**RE: Ghost River Gravel Pit, File No. # M-2024-029, New 112c Application,
Adequacy Review No. 2**

The Division of Reclamation, Mining and Safety (Division/DRMS) is in the process of reviewing the above referenced application and the adequacy responses received by the Division on October 25, 2024 to ensure that it adequately satisfies the requirements of the Colorado Mined Land Reclamation Act (§ § 34-32.5-101-34-32.5-125) (Act) and the associated Rules and Regulations for the Extraction of Construction Materials (Rules). During review of the material submitted, the Division determined that the following issues of concern shall be adequately addressed before the application can be considered for approval.

Items numbered 1-31 address the responses to the initial adequacy review. Portions in **bold text** require additional action/clarification. Item **number 32** is a new adequacy item to be addressed.

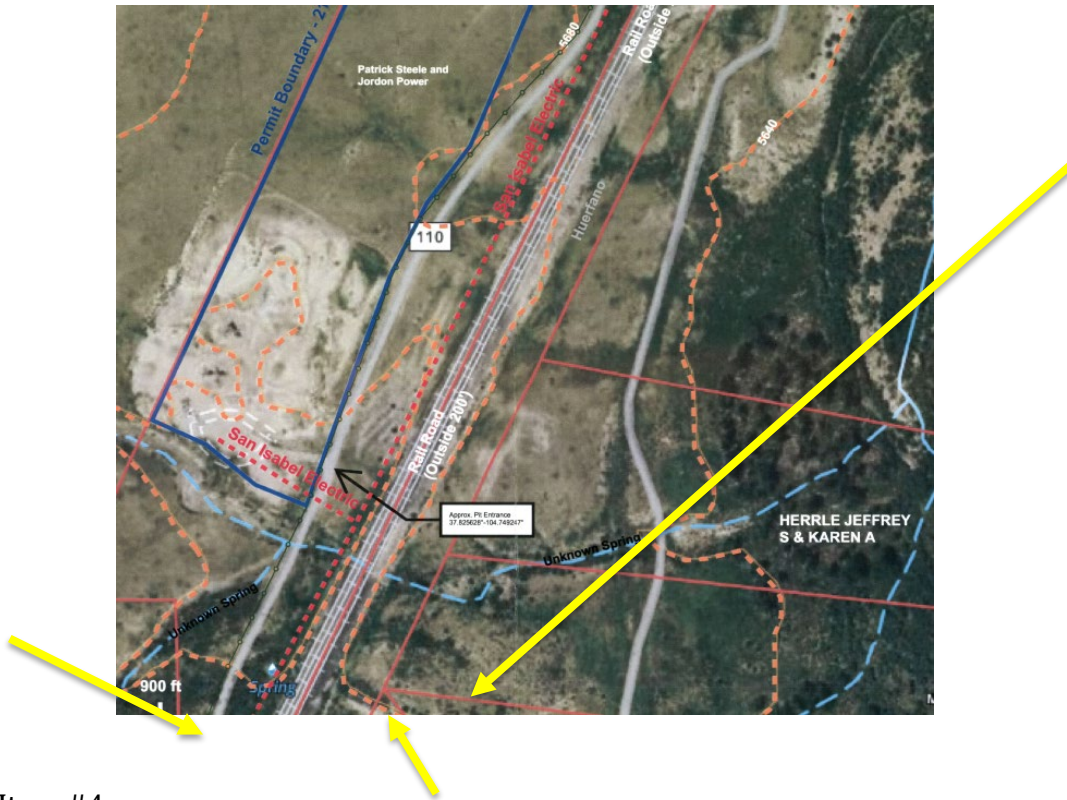
4. *On the Exhibit C – Existing Conditions map and the Exhibit D – Mining Plan Map, at least two property parcels (located south-east and adjacent to the Applicant’s property) do not indicate the property owner(s). Additionally, the Applicant’s southern property boundary is not shown on the map (see yellow arrows on the image below).*
→ *Please provide the names of all adjoining surface owners of record, pursuant to Rule 6.4.3(a).*

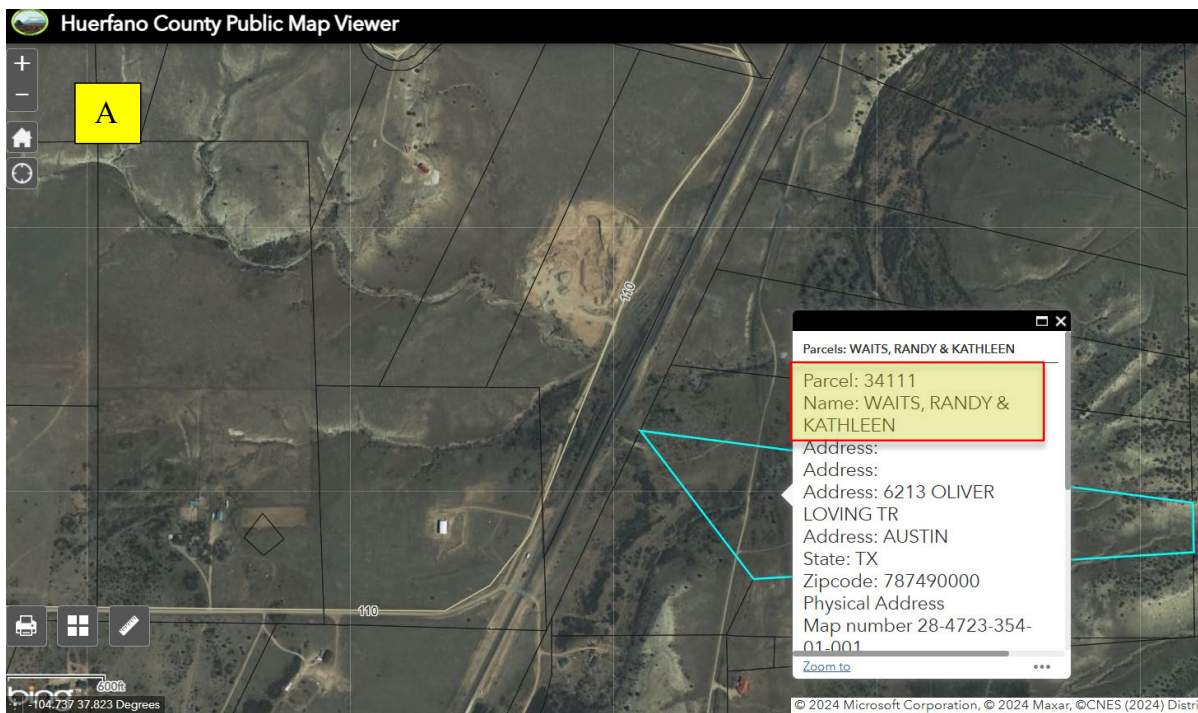
- The Applicant provided the updated names for these two parcels (shown below). However, in image 'A' below (sourced from the Huerfano County assessor site) there appears to be a discrepancy regarding the owners for parcel no. 34111.

--Please determine which is correct, clarify the owner information with the Division, and resubmit the map if the recent submission is incorrect.

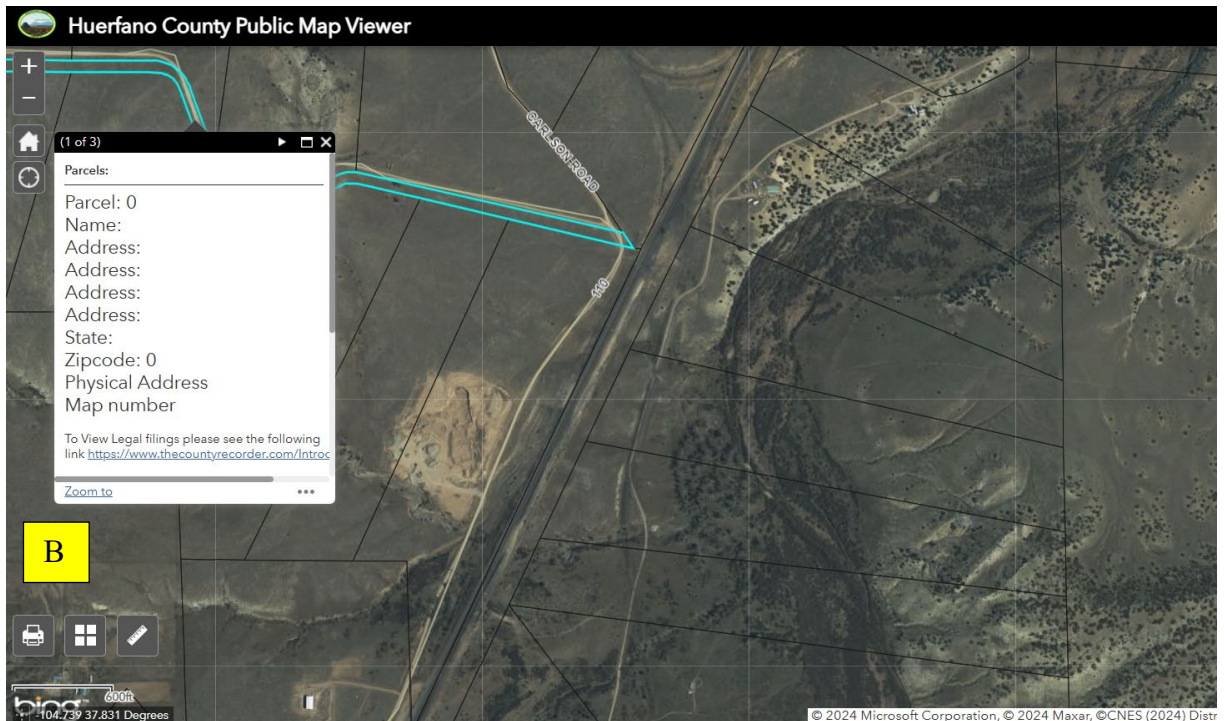
- According to the parcel map on the Huerfano County Assessor site, there appears to be an additional partial to the north of the parcel owned by the applicant (see 'B' below). However, no parcel information is provided on the site.
--Please determine which is correct, clarify the owner information with the Division, and resubmit the map if the recent submission is incorrect.

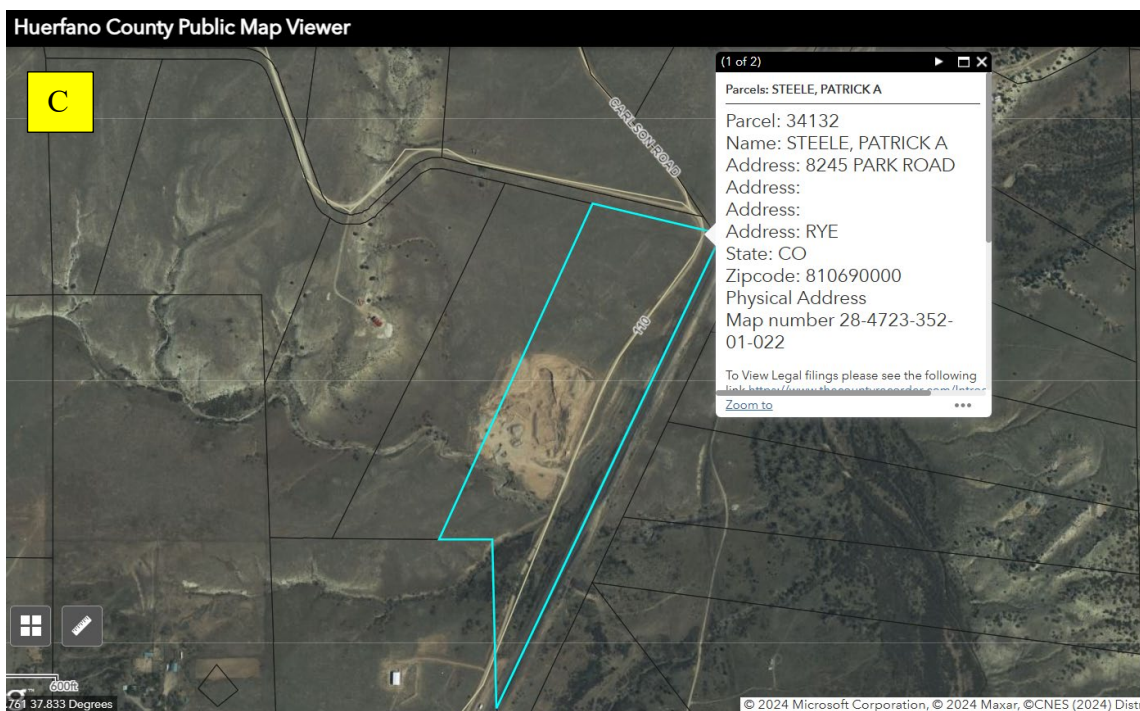
- The map submitted with the adequacy responses does not show the southern boundary of the map. In image 'C' below, it appears that the Applicant's parcel abuts only two parcels on its south end with the west belonging to 'Villard, Sean M' and the east to the Railroad.
--Please confirm whether this information is correct and if so, the map does not need to include the southern tip of the parcel.

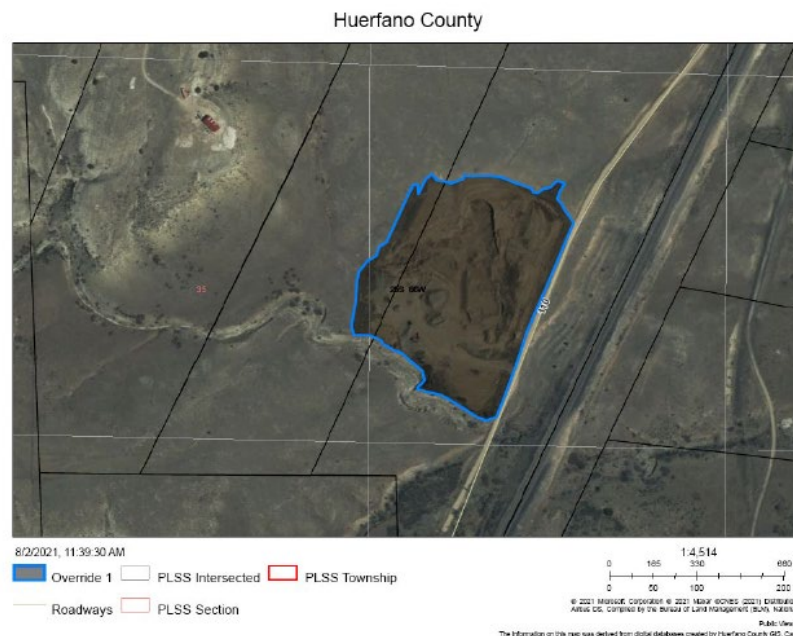
- The Applicant added a figure and a couple corresponding sentences above the figure to briefly outline the disturbance caused by the previous permitted operation.
--Please provide a more detailed description of the current/pre-existing disturbance onsite (highwall, stockpiles, access road(s), etc.).
--Please describe what disturbance exists adjacent to the newly proposed permit area that is not to be re-disturbed during this operation.

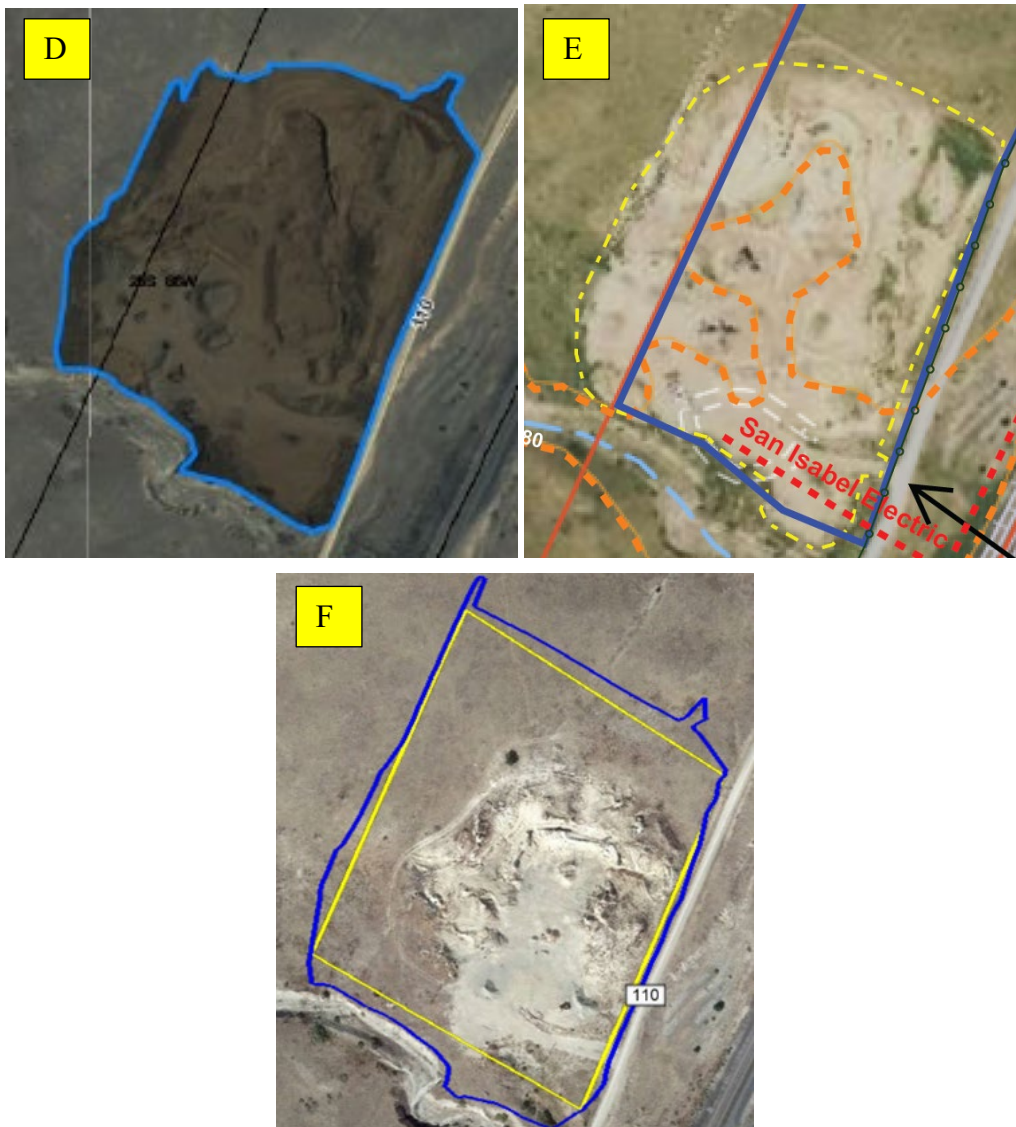
- The figure added to the Exhibit D: Mining Plan Narrative (D) differs from the pre-existing disturbance outline added to the Exhibit D: Mining Map (E) and from the Division's inspection map included in the Division's July 28, 2021 report (F). [Bullet item continued below images]

--The Applicant's image (D) is also from the Division's July 28, 2021 inspection report, as there were two approximations of the affected acreage mentioned in the report. The figure showing 11.3 acres of disturbance was included in the report to show more recent aerial imagery than what was available in Google Earth at that time. The 11.8 acre disturbance boundary was sourced from the Division walking along the actual disturbance onsite, and therefore was the reference for the affected land outside of the permit boundary violation found by the Mined Land Reclamation Board (Board).

--Please update the Exhibit D Mining Plan to reflect that the existing disturbance is 11.8 acres.

--Please update the Exhibit D Mining Map with the pre-existing disturbance boundary and resubmit the exhibits.

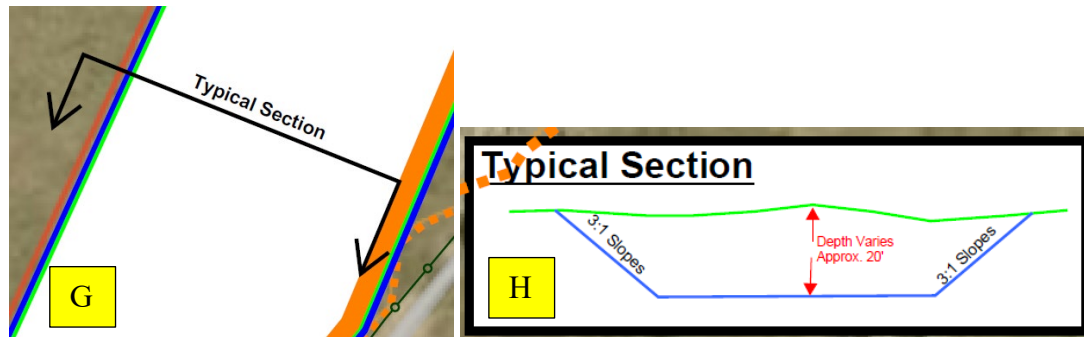
- The Applicant clarified that "the Mine Plan has been updated to state that the interior haul road will remain. The cross-section on Exhibit D Map has been updated as well".
- The reference for the cross section on maps (see image (G) below) does not correspond with the cross section (see image (H)). The east side of the reference abuts the haul road, therefore the right side should end at the top of the blue slope – unless there is to be some additional surface area between the top of the pit slope and the haul road.

1. Include the haul road in the reference section (G), and on the cross section (H) itself.

2. Erase the green surface portion on the right/east side of the cross section (H).

3. Clarify in the Exhibit D Mining Plan that there will be additional area left between the top of the pit slopes on the east side and the west side of the haul road and resubmit the exhibit.

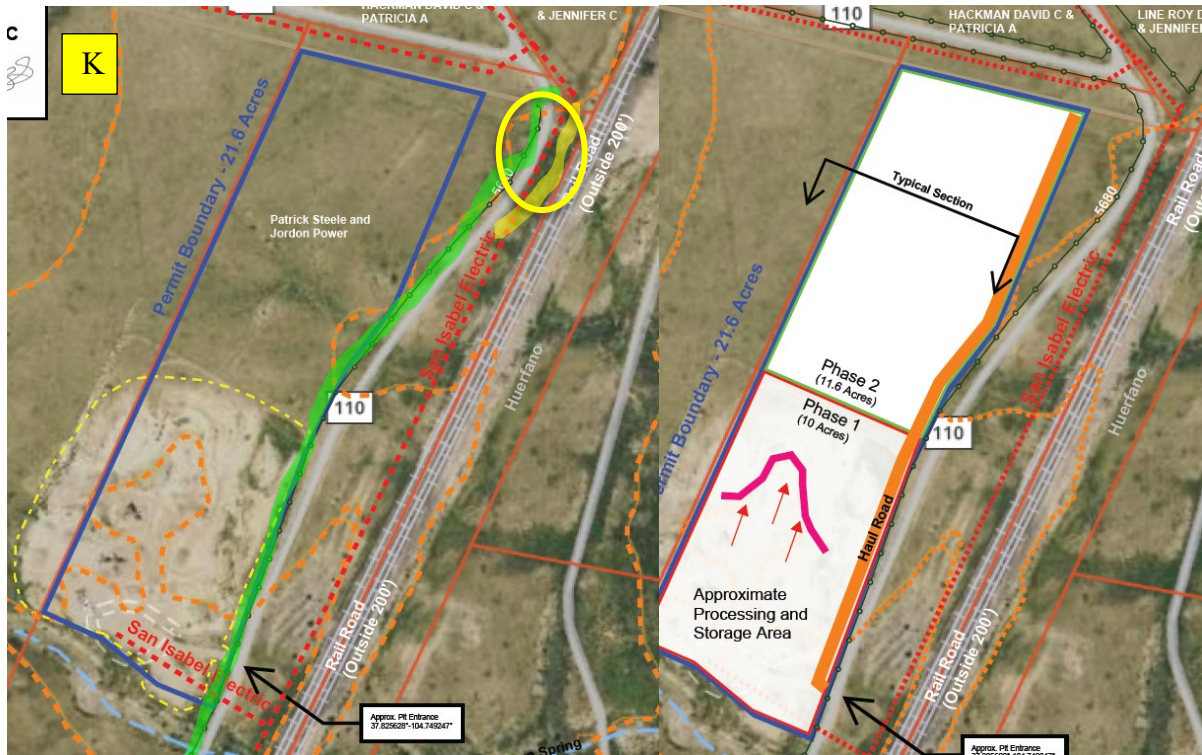
- The Applicant stated that “During the site inspection, it was found that no structures that are not already accounted for, are within 200’ of the permit boundary, and thus no additional structure agreements are needed”.
- The maps submitted with the adequacy responses still indicate that there is a fence along the east side of the permit boundary (see the green highlighted fence in Image (K) below), although we found that this fence no longer exists.
--Please remove this fence from the Exhibit C maps and resubmit the maps.

- During the pre-operation inspection, the Division observed a fence along the east side of County Road 110, that the Applicant stated (during the inspection) belonged to the railroad (see circle in Image (K) above and approximate corresponding location to the fence in Image (L) below).
--Please clarify whether the fence extends southward along the east side of County Road 110, or if it follows the red dotted line on the map. If it's the former, please provide the Division with a required document pursuant to Rule 6.4.19 (see Adequacy Concern 28 above). If it's the latter, please confirm that the entire length of the Railroad's fence is at least 200' away from the permit boundary.
